ROCKY FLATS SITE REGULATORY CONTACT RECORD

Purpose: Rocky Flats Legacy Management Agreement Attachment 2: Modification to Revise Monitoring Points

Contact Record Approval Date: July 15, 2010

Figure 1. Monitoring and Dam Breach Locations—Woman Creek Drainage Area

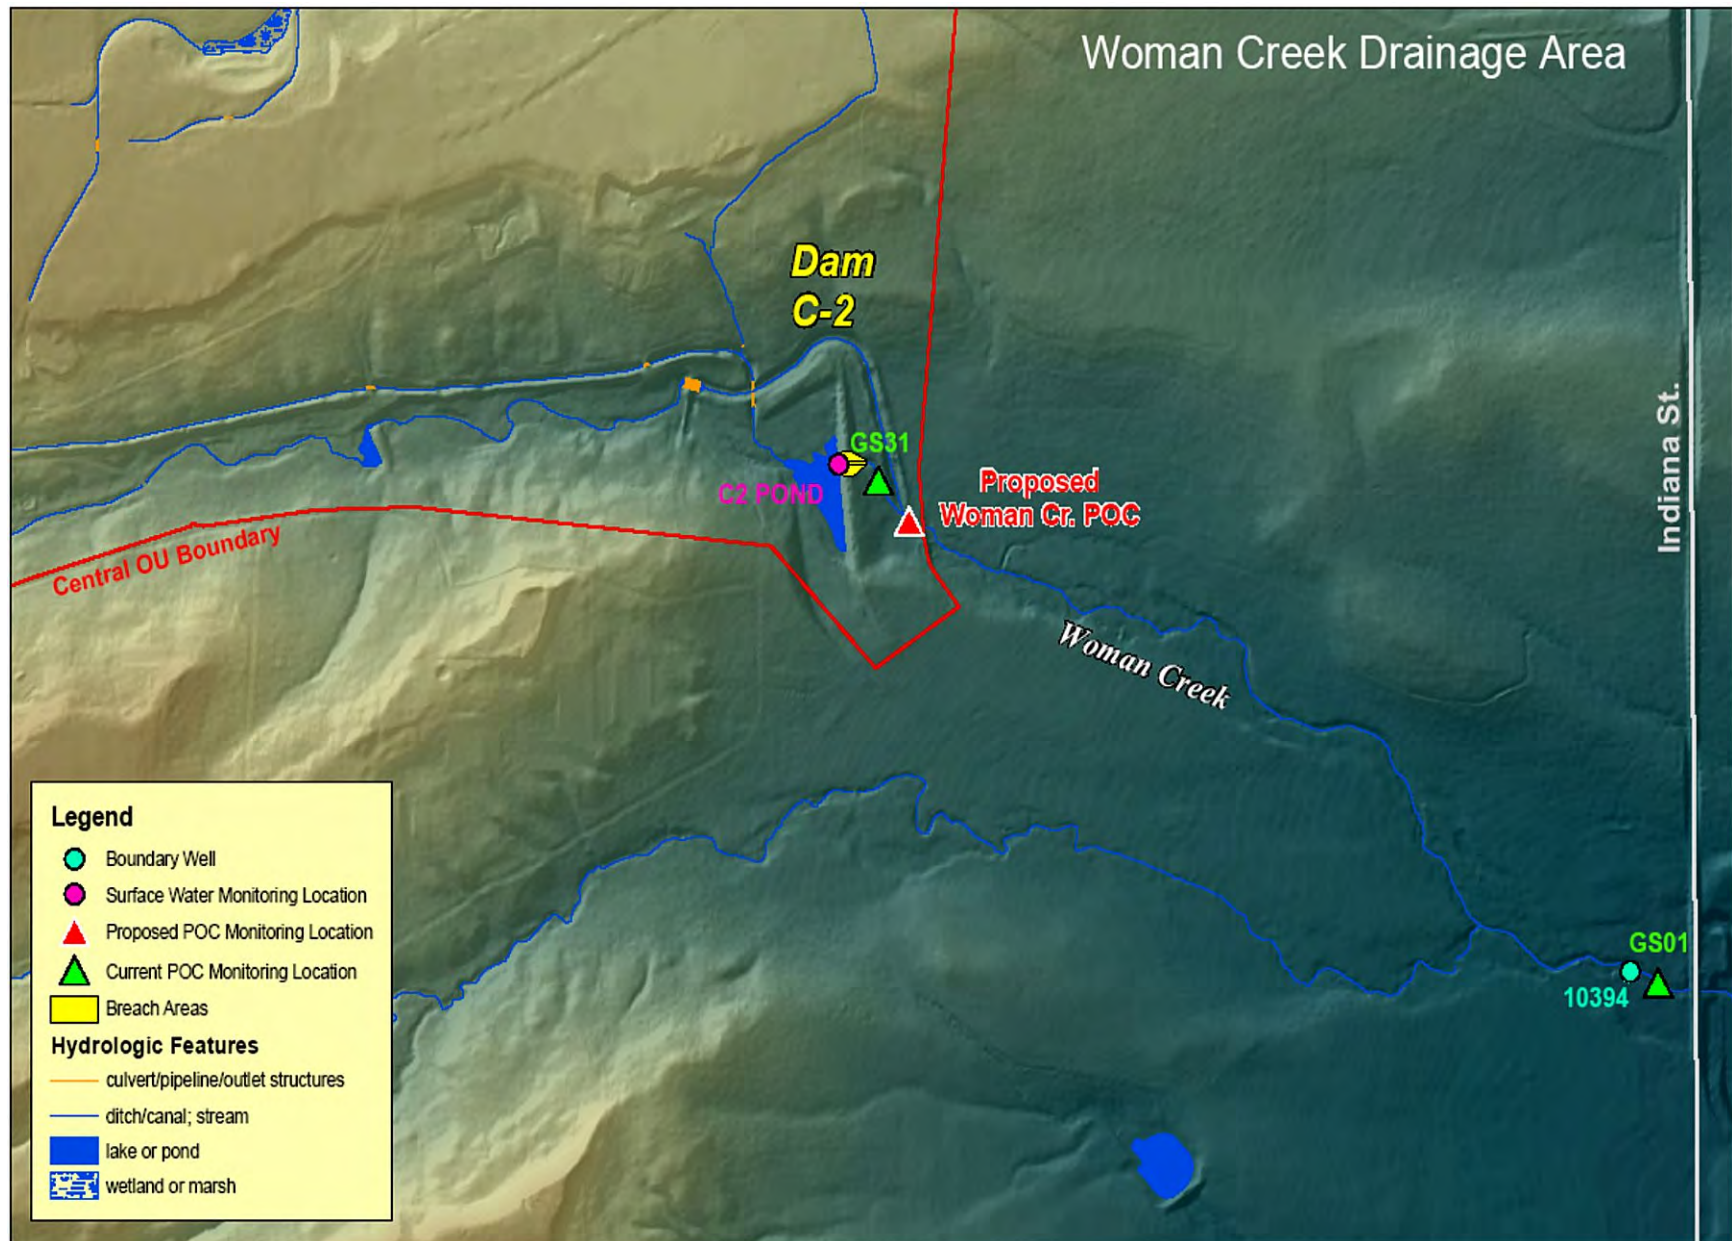
Figures 1 and 2 in this Contact Record also show the current required monitoring locations, the monitoring locations that DOE proposes to eliminate, and DOE’s proposed new monitoring locations. The relevant monitoring locations are listed in Table 1 as well. Figures 1 and 2 also show the locations of the remaining ponds and dams and the approximate footprints of the construction areas for the proposed dam breach based on the preliminary design used in preparing the EA.

GS31	Surface water POC—At outfall of Pond C-2 upstream of Woman Creek	Yes	Yes	Replace with new POC in Woman Creek near COU boundary. Compliance value remains based on 12-month rolling average, but DOE will use 30-day rolling average to trigger consultation with CDPHE on whether mitigating actions are required.
PLFPONDEF	Surface water grab sample location to determine water quality downstream of Present Landfill Treatment System if treatment system effluent exceeds RFLMA standards	No	Yes	A new sampling point ID will be assigned. Grab sample location will be in No Name Gulch near the proposed PLF dam notch after notching. This is the approximate downstream location of the current PLFPONDEFF location.
Pond A-4	Operational monitoring surface water grab sample location for pre-discharge sampling	No	Yes	Remove—operational monitoring not needed; pre-discharge sampling no longer relevant once surface water flow-through condition is restored.

Figure 2. Monitoring and Dam Breach Location—Walnut Creek Drainage Area

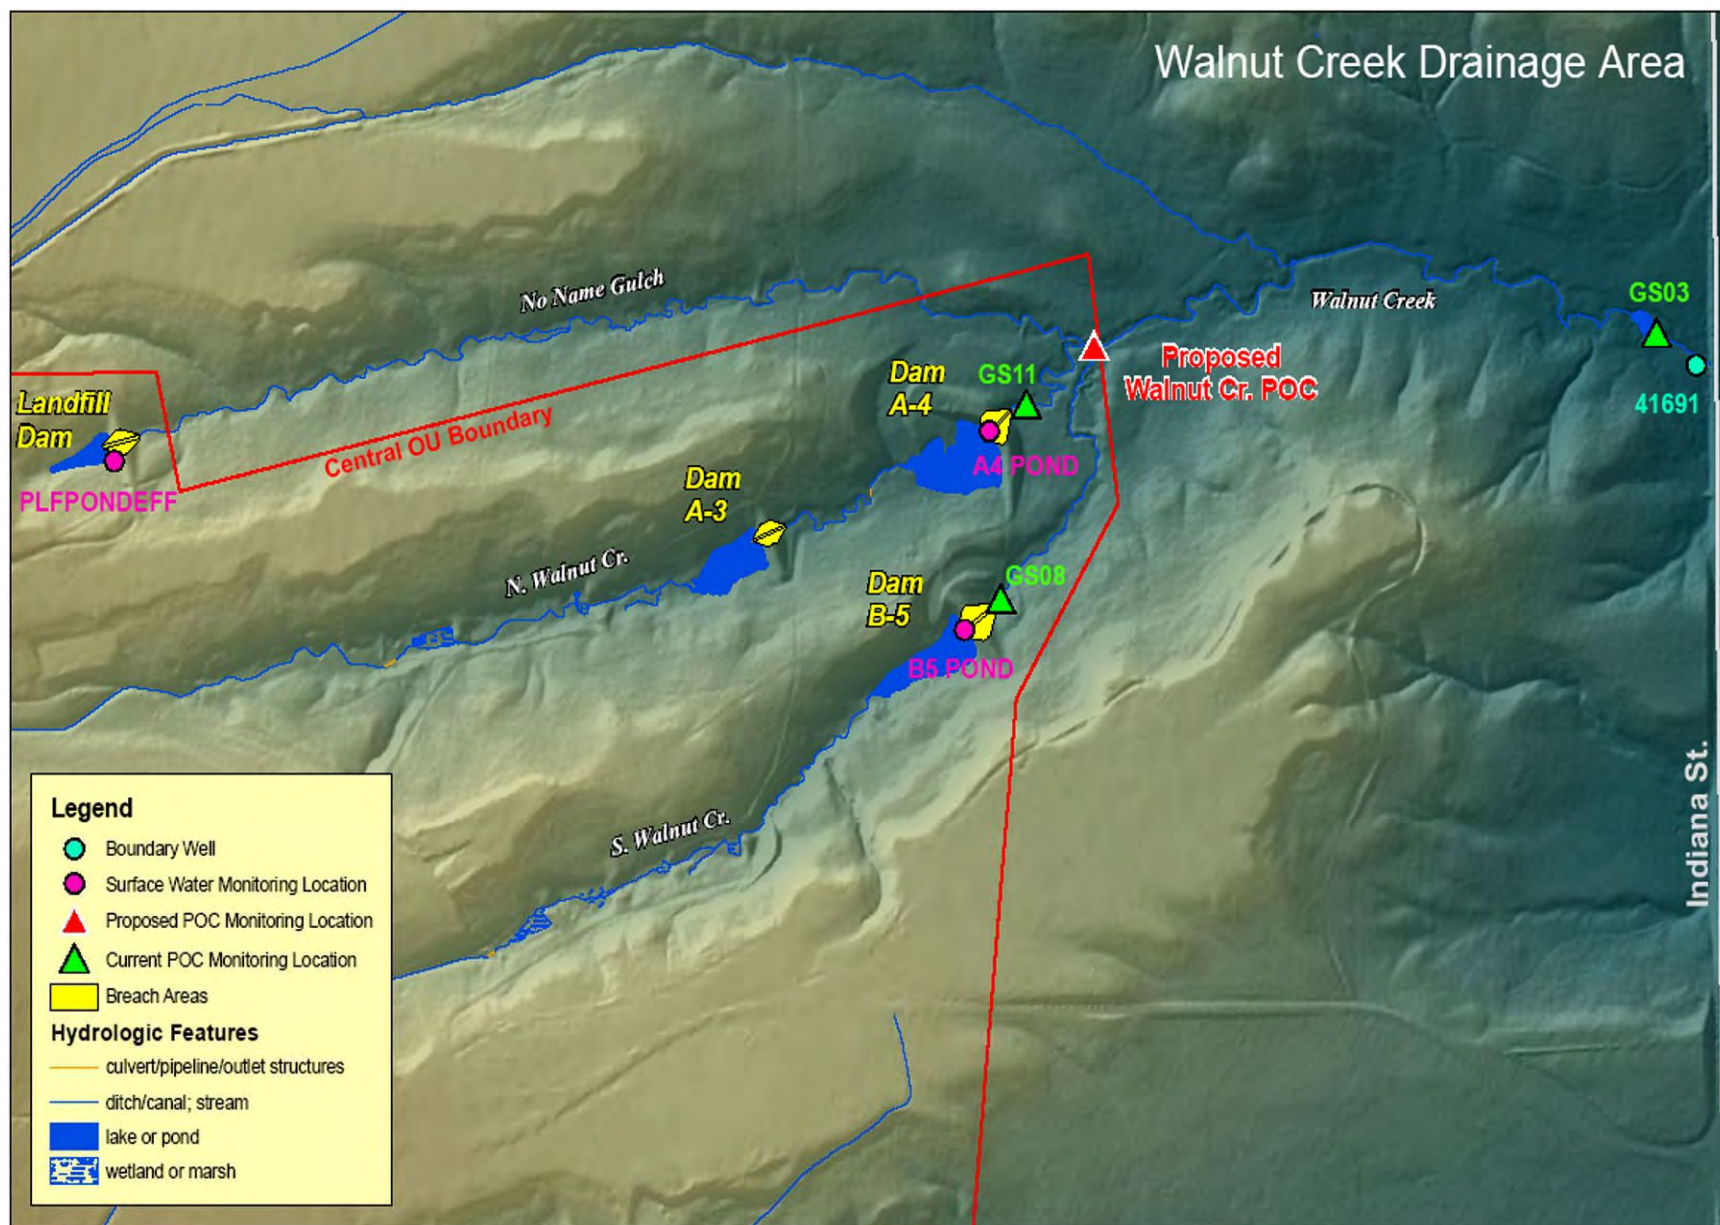
ID	Location	Identified in CAD/ROD	Required by RFLMA	Proposed Change
GS01	Surface water Point of Compliance (POC)—Woman Creek at Indiana St.	Yes	Yes	Remove—not part of NPL site. POC is upstream in Woman Creek at the Central Operable Unit (COU) boundary. GS01 is in the Northwest Parkway proposed route.
GS03	Surface water POC—Walnut Creek at Indiana St.	Yes	Yes	Remove—not part of NPL site. POC is upstream in Woman Creek at COU boundary. GS03 is in the Northwest Parkway proposed route.
GS08	Surface water POC—South Walnut Creek at outfall of Pond B-5	Yes	Yes	Replace with new POC near COU boundary at confluence of North and South Walnut Creeks. Compliance value remains based on 12-month rolling average, but DOE will use 30-day rolling average to trigger consultation with CDPHE on whether mitigating actions are required.
GS11	Surface water POC—North Walnut Creek at outfall of Pond A-4	Yes	Yes	Replace with new POC near COU boundary at confluence of North and South Walnut Creeks. Compliance value remains based on 12-month rolling average, but DOE will use 30-day rolling average to trigger consultation with CDPHE on whether mitigating actions are required.
